ST/SG/AC.10/C.3/40/Add.1
21 December 2001

**REPORT OF THE SUB-COMMITTEE OF EXPERTS
ON ITS TWENTIETH SESSION**

Report of the Working Group on Additional Provisions for the Transport of Gases

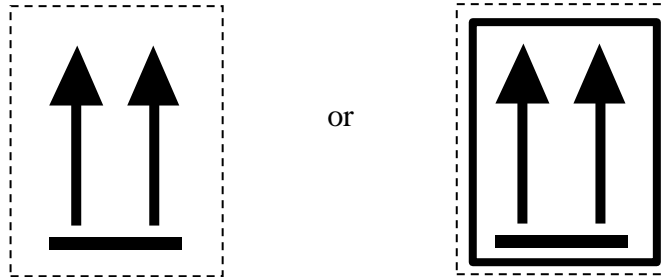
15. Proposal 3 to introduce an orientation label on cryogenic receptacles was accepted subject to the following changes. The standard size was aligned with that specified by ICAO, but smaller or larger labels would be allowed if the size of the package so requires. Options were introduced allowing either red or black arrows and allowing a border. The two formats, with and without a border are to be shown.

5.2.2.1.13 The following orientation label shall be displayed on two opposite sides of cryogenic receptacles intended for the transport of refrigerated liquefied gases. They shall be rectangular, of standard format A7 (74 x 105 mm). If the size of the package so requires, the dimensions of the labels may be changed, provided that they remain clearly visible.

Two black or red arrows on white
or suitable contrasting background
